# Access Compliance Report

## Public Rights-of-Way

Intersection ID: 32277	Main Street: MCALLISTER_PARK_DR	Cross Street: PRESCOTT_HILL_AV	Location: E
ADA ID: 110B298AAEBC	Ramp Type: PerpDiag	Initial Pass/Fail: Fail	Overall Compliance: No
Severity Score: 36.25			
Codes/Mitigation Info/Possible Solution		Field Measurements/Component Compliance

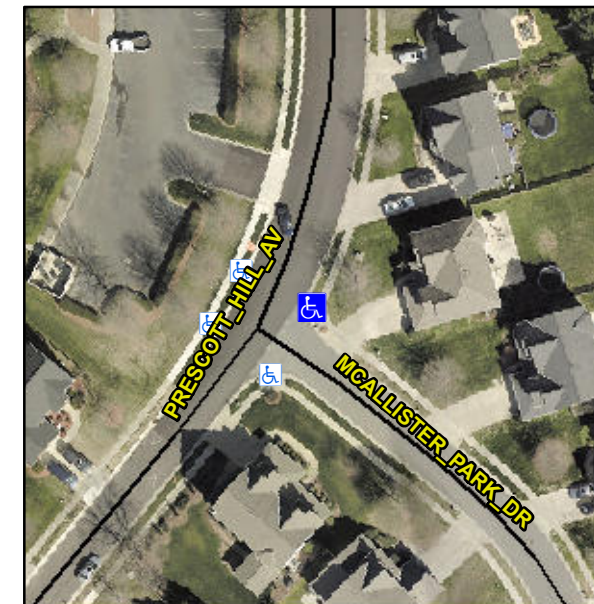
**R304.5.1, R304.5.3**

Compliance	Description	Data	Compliance	Description	Data
N/A	Ramp Length (in)	95.0	Yes	Ramp Slope (%)	6.3
No	Ramp Width (in)	31.0	No	Ramp XSlope (%)	4.2
N/A	Flare Type LT	N/A	N/A	Flare Type RT	N/A
N/A	Flare Slope LT (%)	N/A	N/A	Flare Slope RT (%)	N/A
N/A	Flare Traversable LT?	N/A	N/A	Flare Traversable RT?	N/A
N/A	Landing Length (in)	N/A	N/A	DWS Provided?	N/A
N/A	Landing Width (in)	N/A	N/A	DWS Contrast?	N/A
N/A	Landing Slope (%)	N/A	N/A	DWS Length (in)	N/A
N/A	Landing X Slope (%)	N/A	N/A	DWS Full Width?	N/A
N/A	Landing Curb? (Y/N)	N/A	N/A	DWS Offset (in)	N/A
N/A	Shared Landing?	N/A			
N/A	Gutter Ponding?	N/A	N/A	Gutter Slope (%)	N/A
N/A	Gutter Lip Ht (in)	N/A	N/A	Gutter X Slope (%)	N/A
N/A	Painted X Walk1?	No	N/A	Painted X Walk2?	No
	X Walk 1 Direction	To NW		X Walk 2 Direction	To SW
N/A	X Walk 1 Width (in)	N/A	N/A	X Walk 2 Width (in)	N/A
	X Walk 1 Slope (%)	2.6		X Walk 2 Slope (%)	0.1
	X Walk 1 X Slope (%)	1.1		X Walk 2 X Slope (%)	2.6

N/A	Ramp inside XWalk1?	N/A	N/A	Ramp inside XWalk2?	N/A
	Road Slope (%)	2.8	N/A	Clear Space?	N/A
	Road X Slope (%)	1.1	N/A	Clear Space to XWalk (in)	N/A
N/A	Any Obstructions?	N/A	N/A	Storm Grate/Utility Hazard?	N/A
	Obstruction Type			Storm Grate/Utility Type	
		N/A			N/A
		Yes		Surface Condition? (G/P)	Good

**Remove & Replace Curb Ramp With Two New Directional Ramps or Equivalent.**
